PROJECT NAME: Alvarado Intermediate School Partial Modernization
BID NO: 2010/11:13
DSA NO: 03-112358

ADDENDUM NO: 4
DATE: May 12, 2011

ADDENDUM NO. 4

Rowland Unified School District Alvarado Intermediate School Partial Modernization

AD4-A10C DATE: 5/10/2011

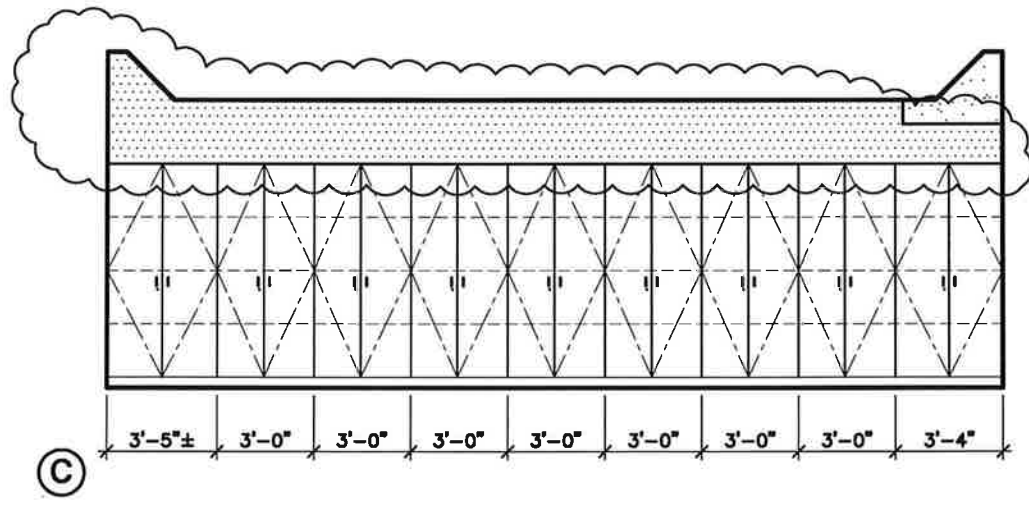
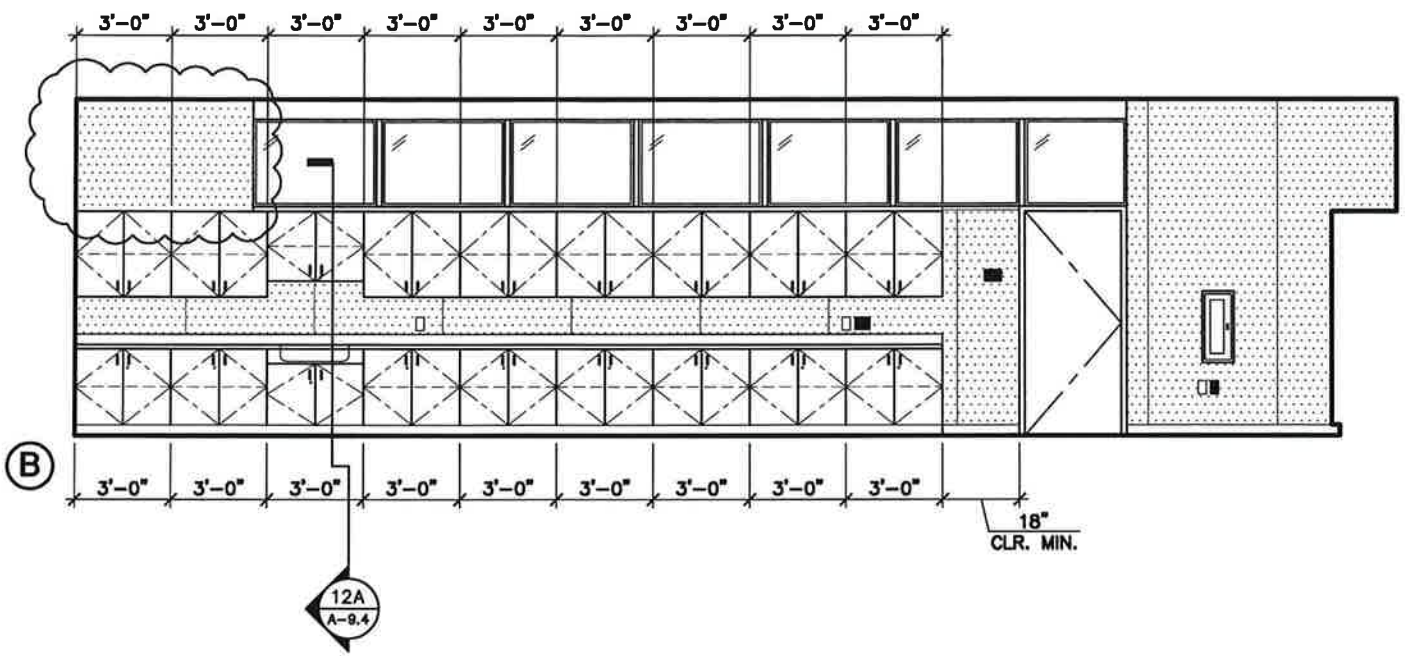
19. REVISE: At Detail 6 - Interior Elevations Science-71 (Bldg. K1-A)
Per Attached drawing **AD4-A10C**, dated May 10, 2011.
20. REVISE: At Detail 8 - Interior Elevations Science-72(Bldg. K1-A)
Per Attached drawing **AD4-A10D**, dated May 10, 2011.
On SHEET A-7.2
21. REVISE: At Detail 6 - Interior Elevations Science-73 (Bldg. K1-A)
Per Attached drawing **AD4-A10E**, dated May 10, 2011.
On SHEET A-8.0
22. ADD: At Door Schedule
Doors C1-1A, C2-1A, C3-1A, C4-5A, C5-1A, and C6-5A per attached drawing **AD4-9G**, dated May 10, 2011.
On SHEET A-9.2
23. REVISE: At Detail 12 - Typical Soffit
Per attached drawing **AD4-A7**, dated May 10, 2011.
On SHEET A-9.4
24. REVISE: At Detail 6 - Learning Wall Unit Elevation (For Reference Only)
Per attached drawing **AD4-A8**, dated May 10, 2011.

AD4-A11A DATE: 5/10/2011

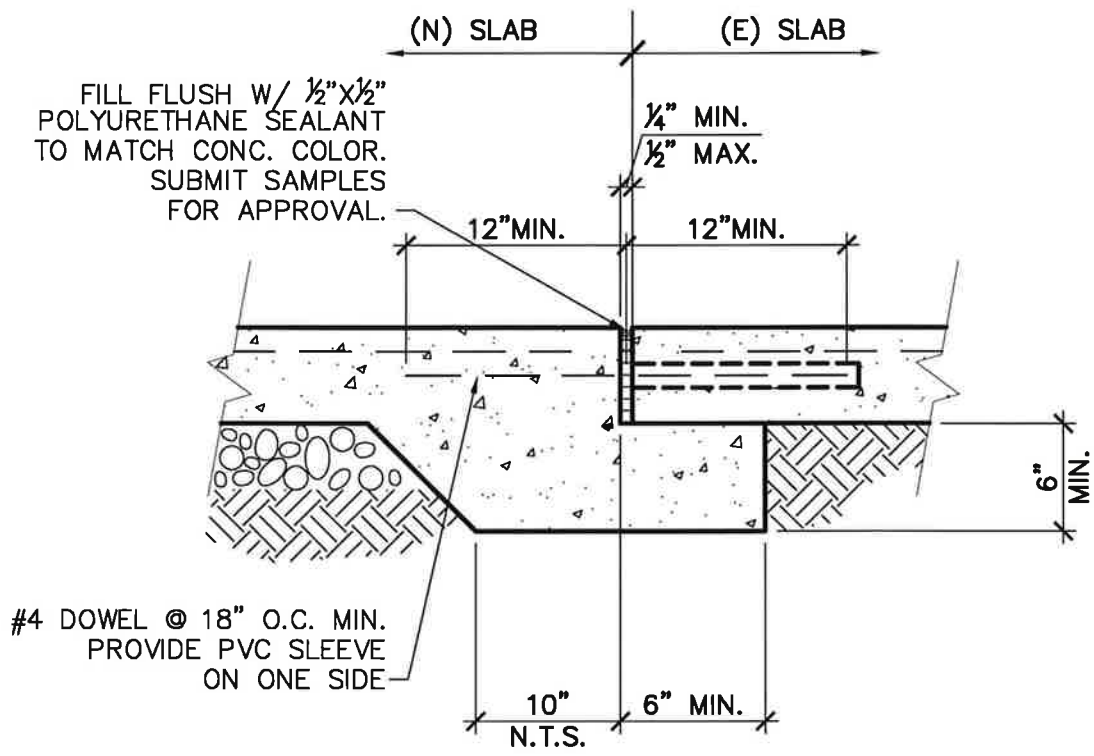
10. REVISE: Section View detail per attached drawing **AD4-A11A**, dated May 10, 2011.

TYP. NEW TO EXISTING CONCRETE		(REF: C/C-2.3) SCALE: 1 1/2" = 1'-0"
PROJECT TITLE: ALVARADO I.S. PARTIAL MODERNIZATION	DSA NO.: 03-112358 FILE NO.: 19-92 PROJECT NO.: 108RSD13 HENRY WOO ARCHITECTS, INC.	AD4-A11B DATE: 5/10/2011

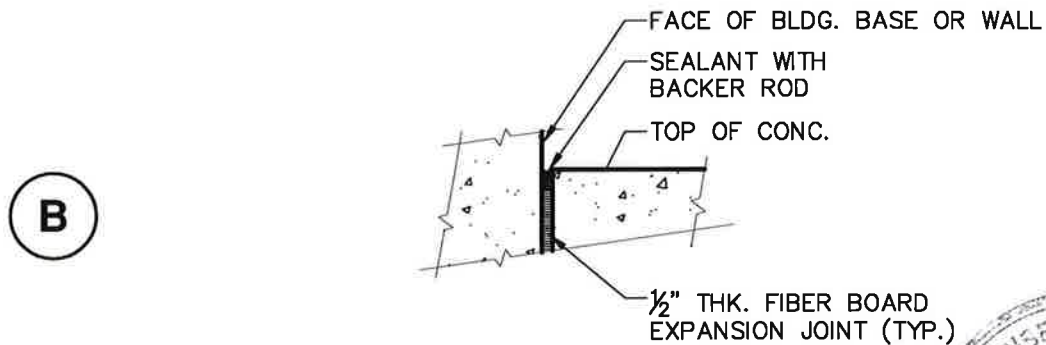
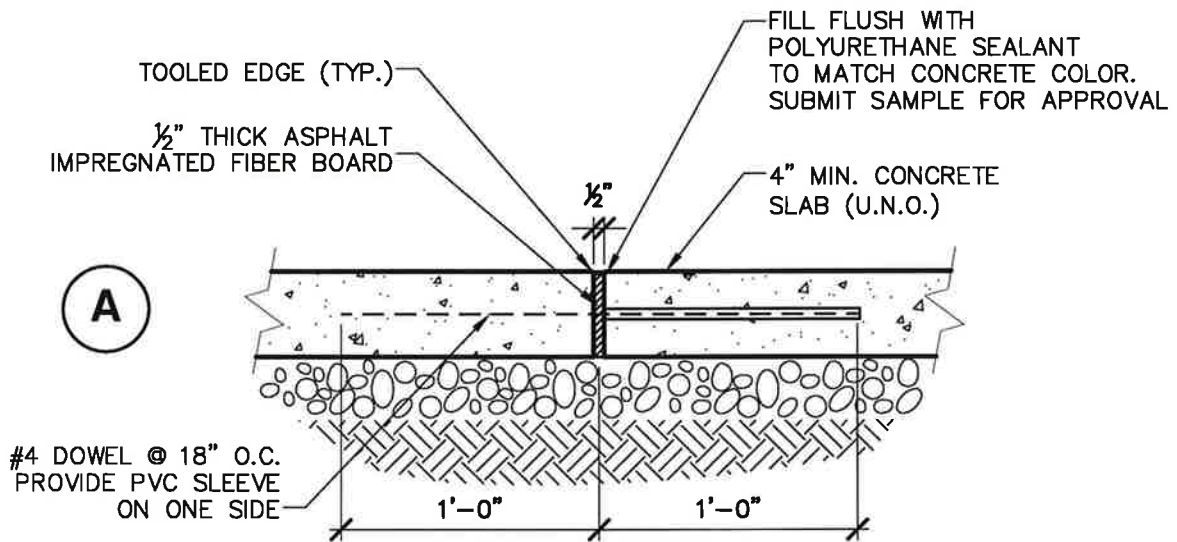
11. REVISE: Doweled Expansion Joint detail per attached drawings **AD4-A11B** and **AD4-A11C**, dated May 10, 2011.

AD4-A11C DATE: 5/10/2011

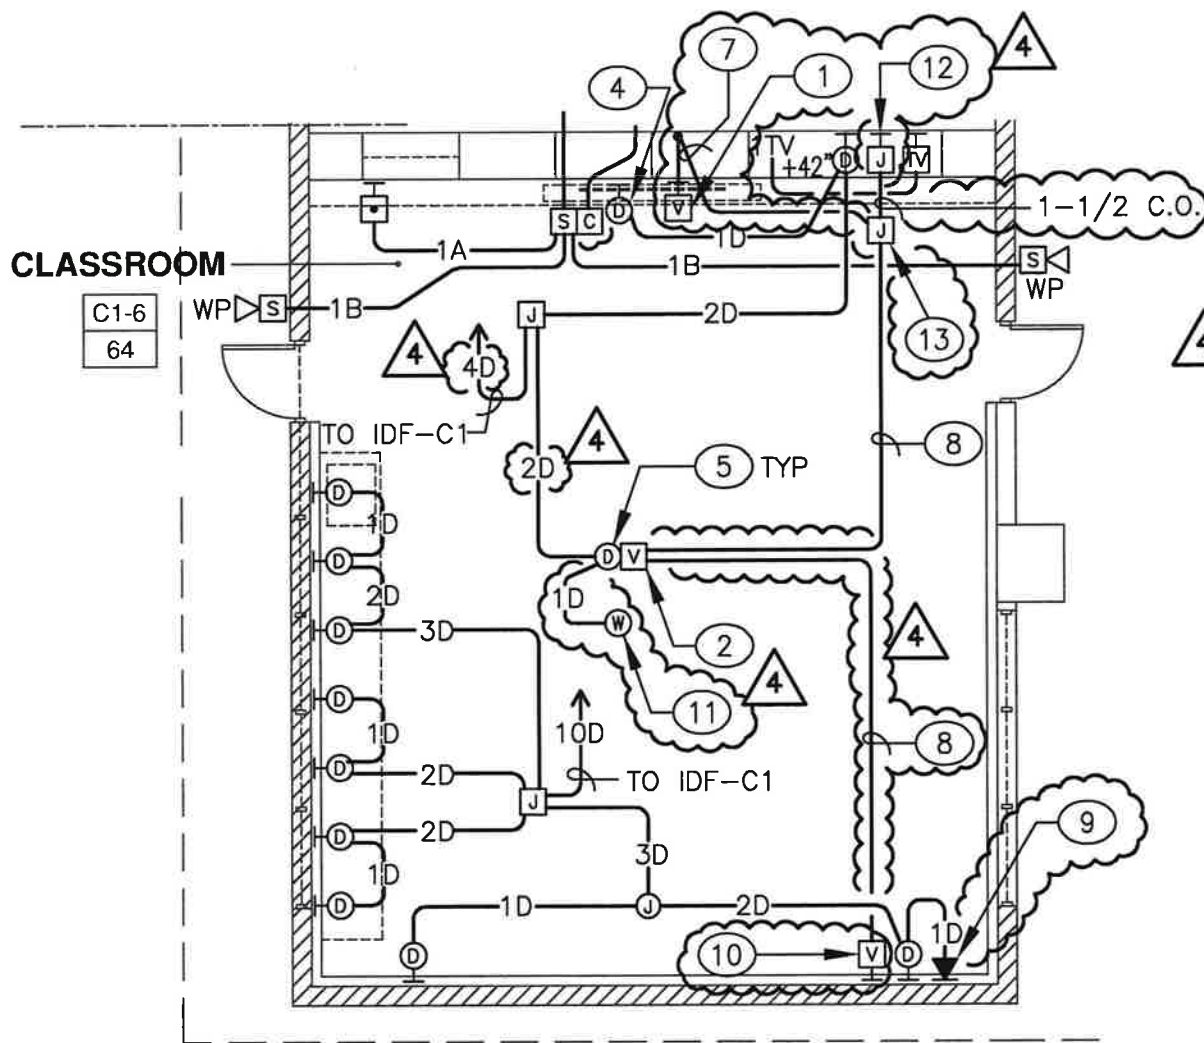
9. ADD: "11. Contractor shall install a doweled expansion joint with waterproof sealant at all join lines between existing concrete paving to remain and new adjacent concrete paving per Detail C/C-2.3.

AD4-E1

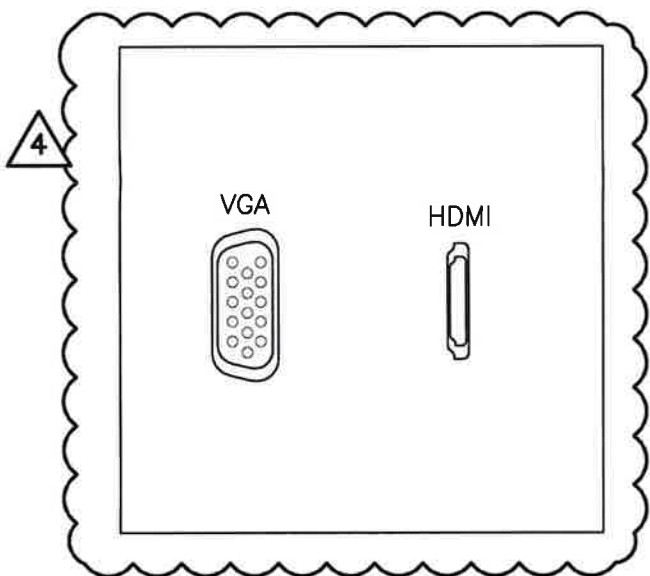
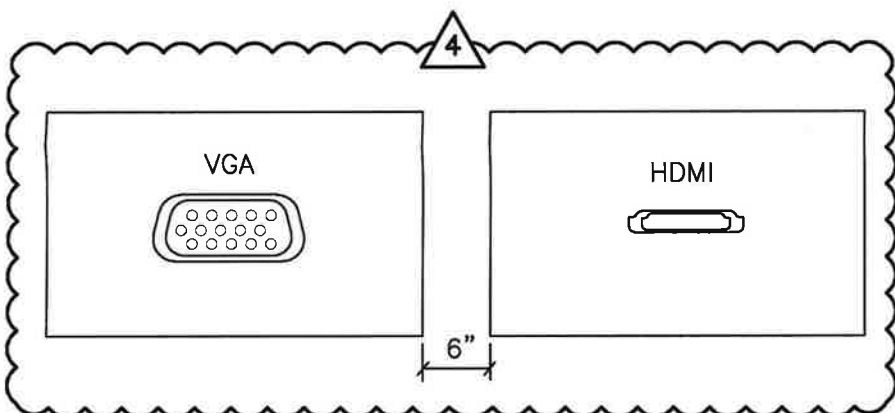
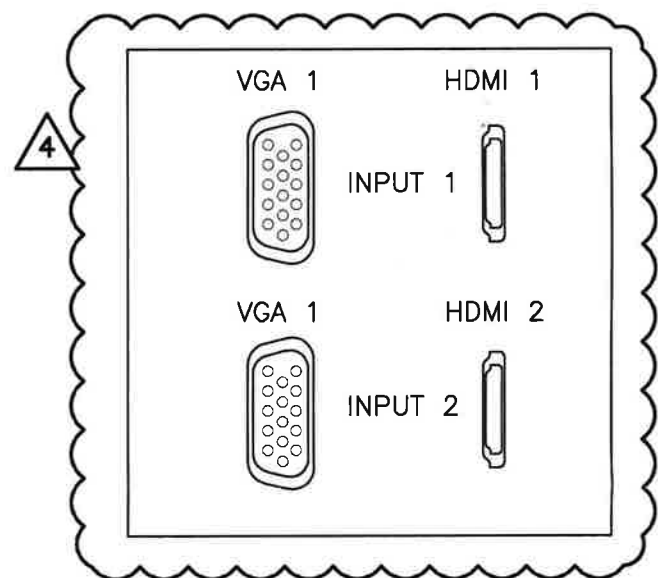
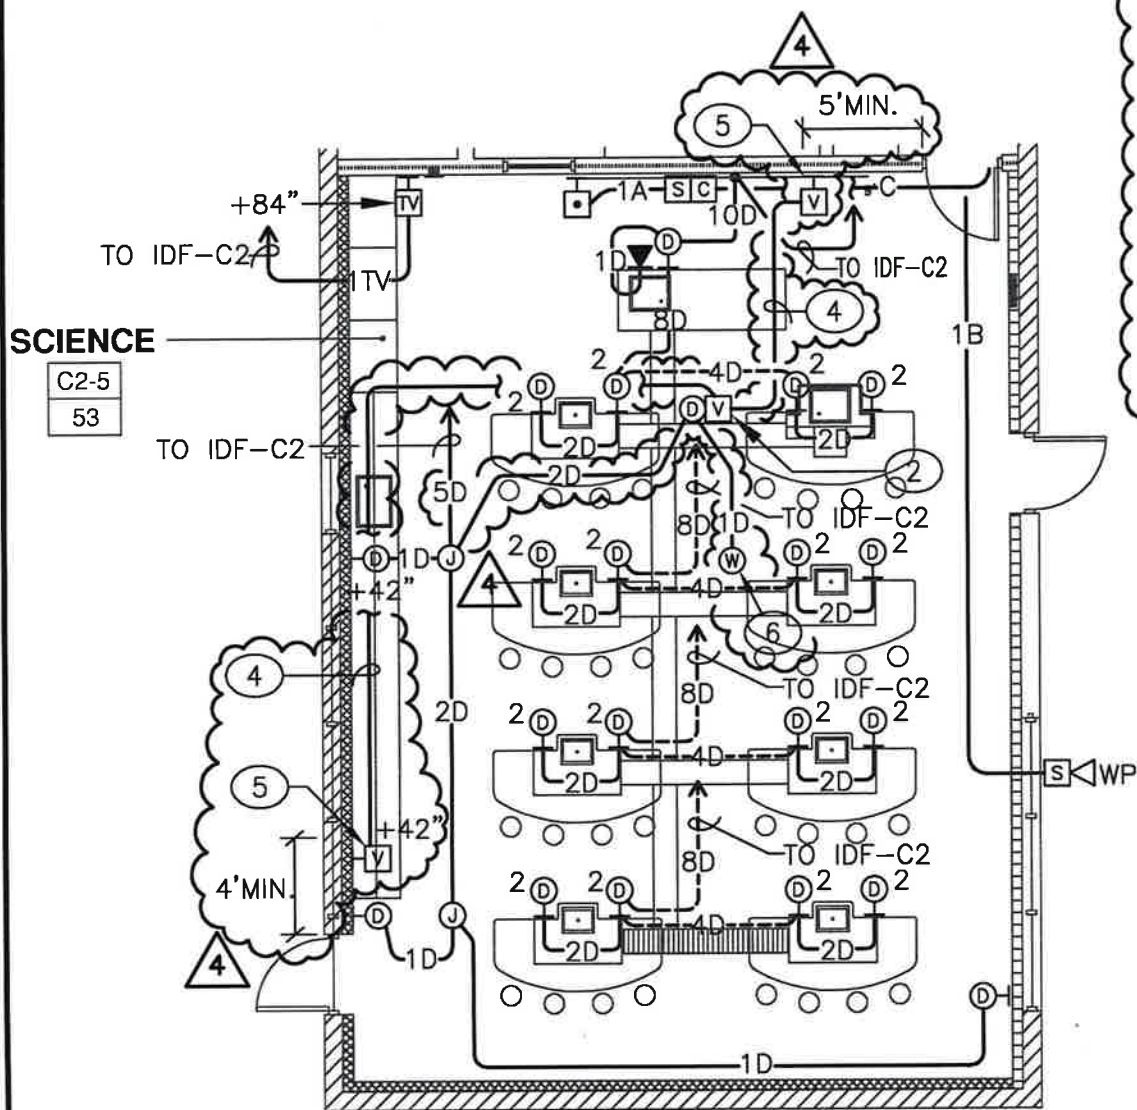
1. **Addendum Drawing AD4-E1** (Reference Drawing E-6.1, Signal Floor Plans Bldgs. C1, C3 & C4). The following changes apply to all classrooms in Bldgs C1, C3 and C4. Similar changes shall also apply to all classrooms in Bldgs. C5 & C6.

- 1.1. Add wireless access point on each classroom.
 - 1.2. Change the input configurations on the media cabinet and ceiling video outlets. Add video outlets on toekick of media cabinet.

- 1.3. Add (1) video wall mounted video outlet at the teacher's station connected to the ceiling mount video outlet.
 - 1.4. Change the conduit size and delete VGA cable to the line from the ceiling down to the media cabinet.

TYPICAL CLASSROOM PARTIAL SIGNAL PLAN & DETAILS

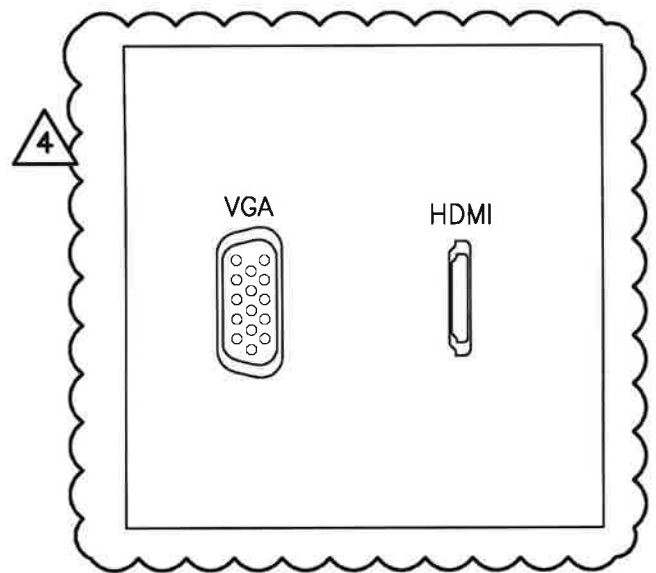
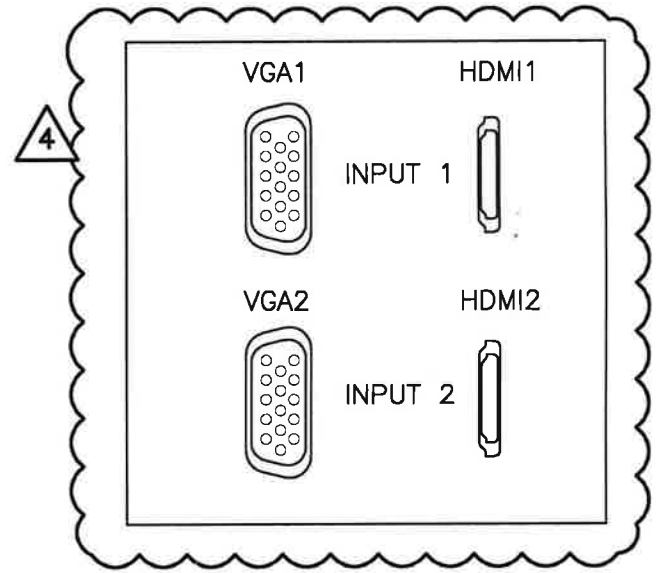
2. **Addendum Drawing AD4-E2** (Reference Drawing – E-6.2, Signal Floor Plans, Bldgs. K1A and C2). The following changes apply to all classrooms in Bldgs K1A and C2.

- 2.1 Add wireless access point on each classroom.
 - 2.2 Change the input configurations on the wall and ceiling video outlets.
 - 2.3 Add (1) video wall mounted video outlet at the alternate teacher's station connected to the ceiling mount video outlet.

- 2.4 Change the conduit size and add HDMI cable to the line connecting the wall and ceiling video outlets.
3. **No Addendum Drawing** (Reference Drawing – E-1.0, Symbol List, Fixture Schedule and Notes):
